MATANUSKA-SUSITNA BOROUGH

ABBREVIATED PLAT AGENDA

July 16, 2025

ABBREVIATED PLAT: REDINGTON ESTATES

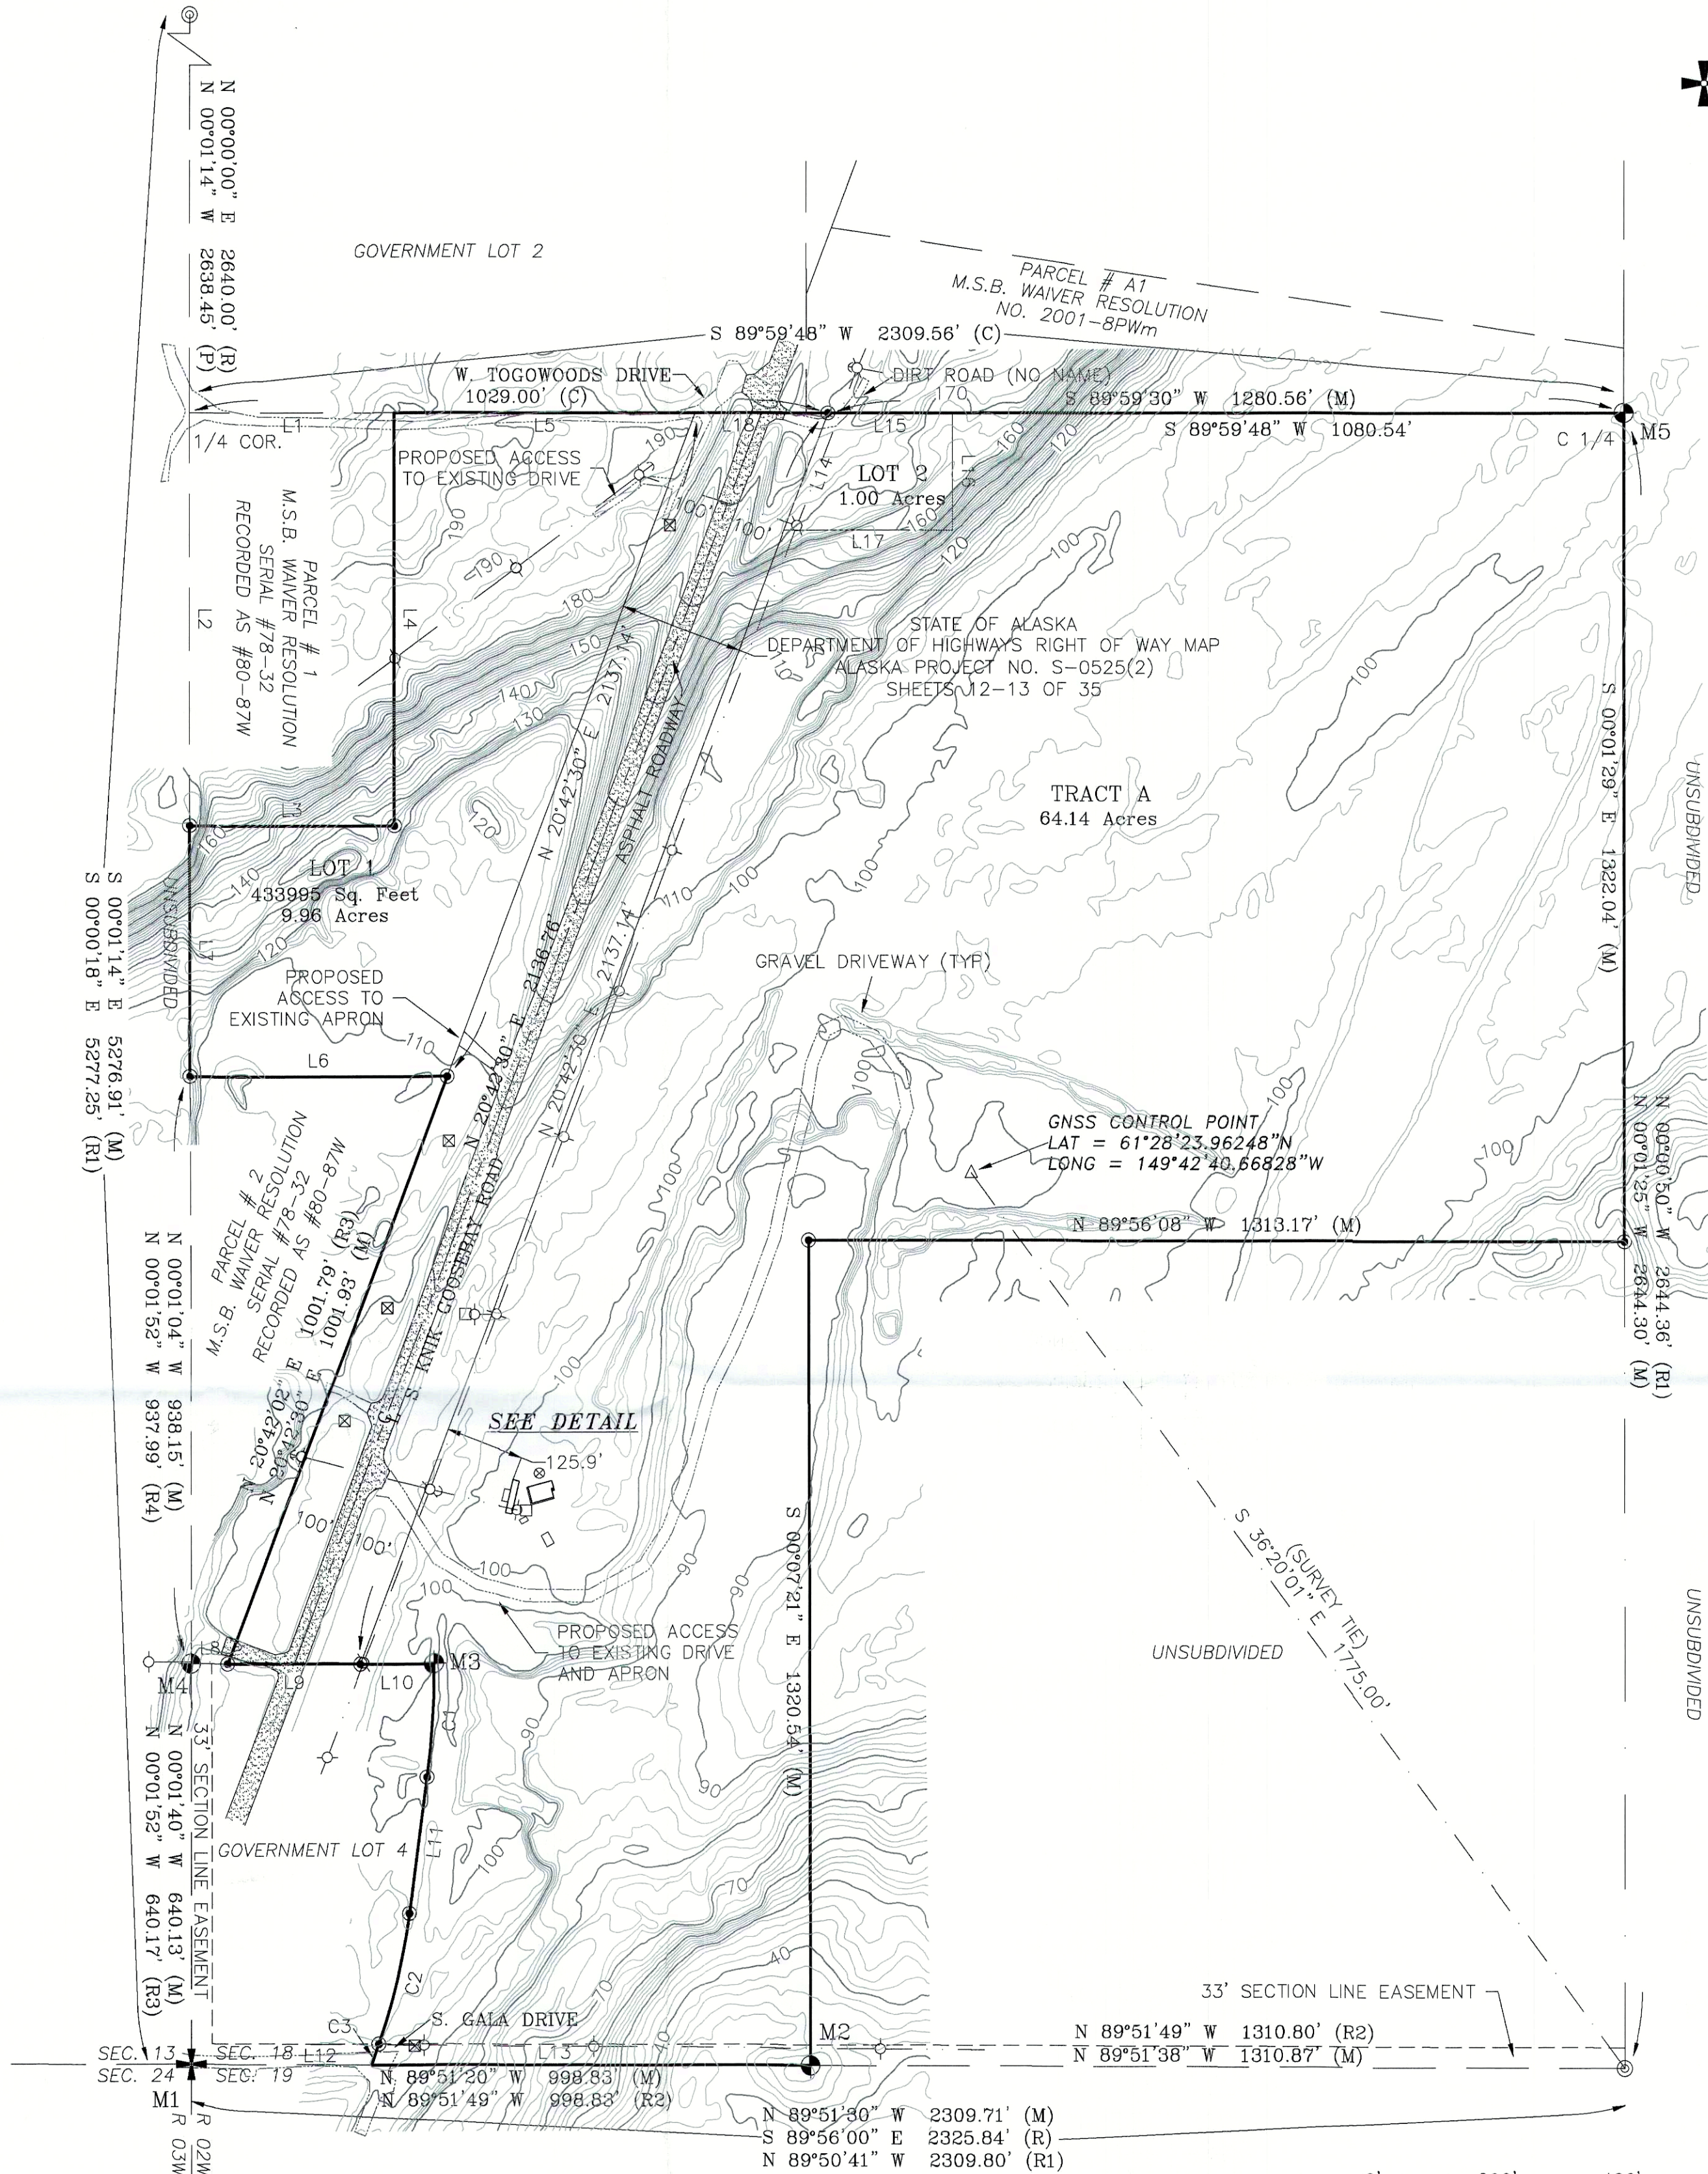
- DOT&PF requests right of way dedication along Knik-Goose Bay Road.
Platting staff notes that this is an abbreviated plat and as such cannot dedicate right-of-way.

- Do not preclude development to Togowoods Drive as future development and formalization of Togowoods Drive may require future access to or through it.

- Single access for Lot 2 and Tract A to Knik-Goose Bay Road. Plan internal circulation and lot development accordingly. Lot 1 access to be determined through permitting process.

- Remove "proposed access" from plat and change labels to say "existing drive," "existing apron," and "existing drive and apron," or remove labels altogether. Existing apron or access location to Knik-Goose Bay Road does not guarantee that access will remain at this location. Driveways and approach roads must go through a technical review process, which will determine access location. The driveway and approach road review are separate to platting actions, and through DOT&PF when requesting access to a DOT&PF facility. Knik-Goose Bay Road is a DOT&PF facility.
Platting staff notes that the agenda plat was submitted with both topographic and as-built information. These items will be removed prior to the recordation of the final plat.

- Joseph E. Redington applied for patent (1129974) on June 7, 1948, therefore a 33' section line easement exists along the western section line per RS 2477. The 33' SLE depicted should be extended north to the quarter line (**Recommendation #5**).

- Please update the KGB Right-of-Way to accurately depict the ROW recorded in Misc Book 6, Page 155 and as shown on the referenced DOT Project S-0525(2). The highway ROW expands to 210' across a 700 foot strip on page 13 (**Recommendation #6**).

- Please update Government Lot 4 to: "A portion of Government Lot 4."
Platting staff notes that the legal description will be correct on the final mylar.
